Alaska Railroad Corporation 327 W. Ship Creek Ave. Anchorage, AK 99501

Addendum 1 ITB#22-46-210046 ARRC Passenger Coach 651-656 Dome Level Seatback Tray Fabrication

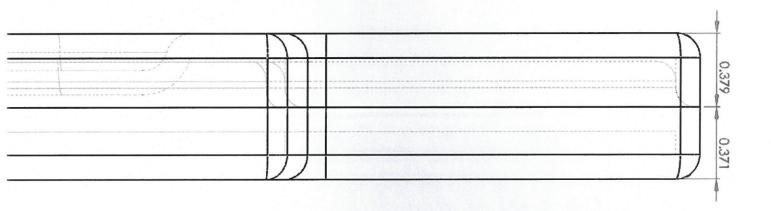
1. Can the tray shell be formed with straight sides that fit over each other for assembly instead of the formed return?

Yes we would accept that tray shell molded with straight sides of the overall dimensions of the tray meet the design as posted.
